# Rezoning Transportation Analysis

Petition Number: #2022-107

Date	Description
11-28-22	First Review (IW)
12-22-22	Second Review (DR)
01-26-23	Third Review (IW)

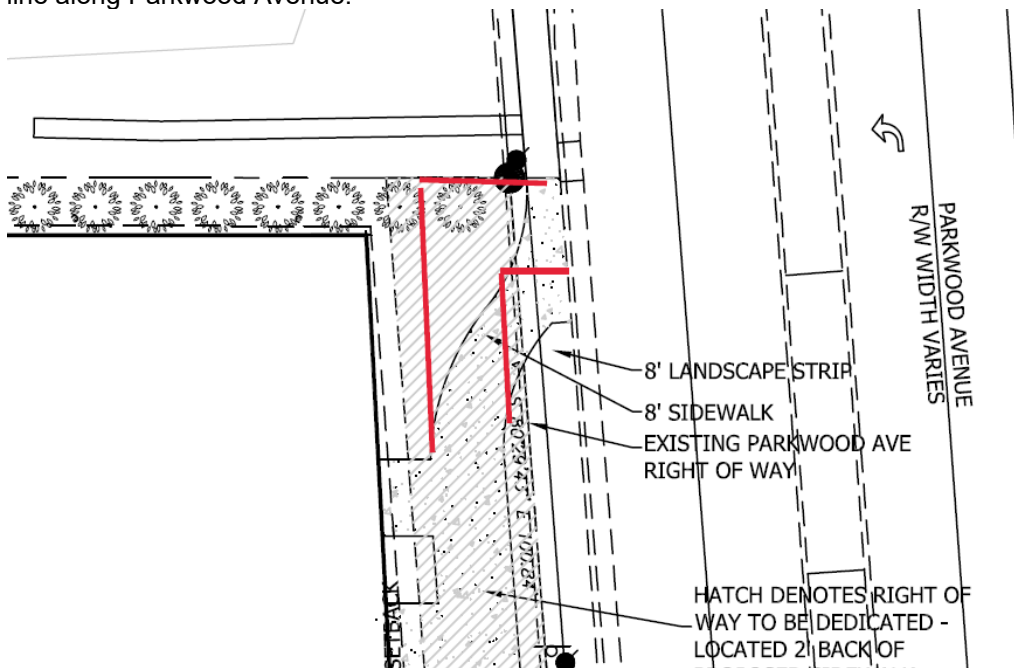
**Clarifying comment from 12/22/2022:** Commit to connect sidewalk near single family structure to existing sidewalk on Mimosa Avenue as shown above.

6. Site plan and conditional note(s) revisions are needed to commit to extending the 8' sidewalk to property line along Parkwood Avenue.

**Clarifying comment from 12/22/2022:** Extend 8-foot sidewalk as shown above to property line along Parkwood Avenue.
